Financial Assurance Policy:

January 08, 2010

In response to your letter dated December 17, 2009, is providing the following information and clarification.

Drawing 1 of 2

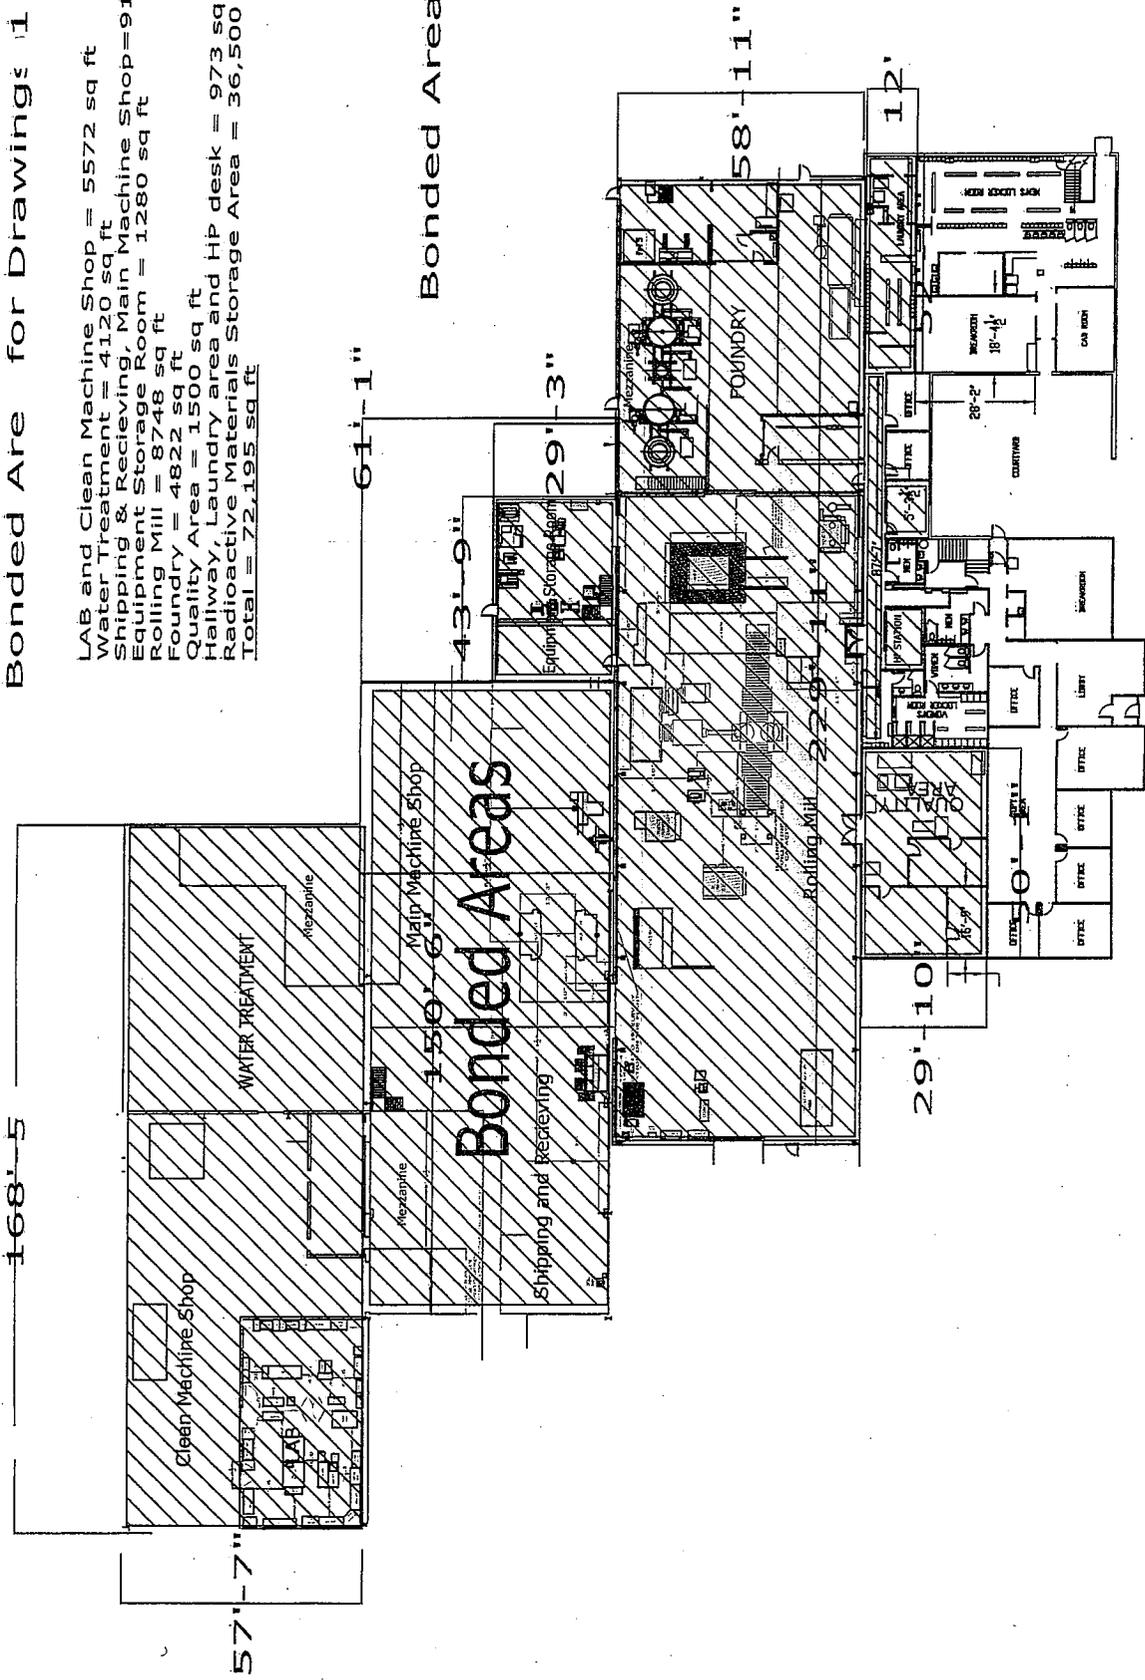
Submit a summary of dimensions and square feet for financially assured (bonded) areas in Attachment 3 of the application including the areas for 4 high stacking (11.8 RSG-1) that show that these areas are covered within the current financial assurance amount of \$7,793,153.00. The 4 high stacking areas must be multiplied by 4.

Response: Included are floor prints with dimensions and square footage noted for financially assured areas. proposes to stack sea land containers 3 high within the Radioactive Materials Storage Area. proposes to stack intermodal containers 4 high but these stacking heights equate to a similar volume to 3 high sea land containers stacked. In reviewing the current Letter of Credit on file with the TDRH the amount assured matches the footprint including using a 3X factor for the Radioactive Materials Storage Area. Two copies of the floor prints are included to be added to Attachment 3 of the "Application for Source Material License Renewal".
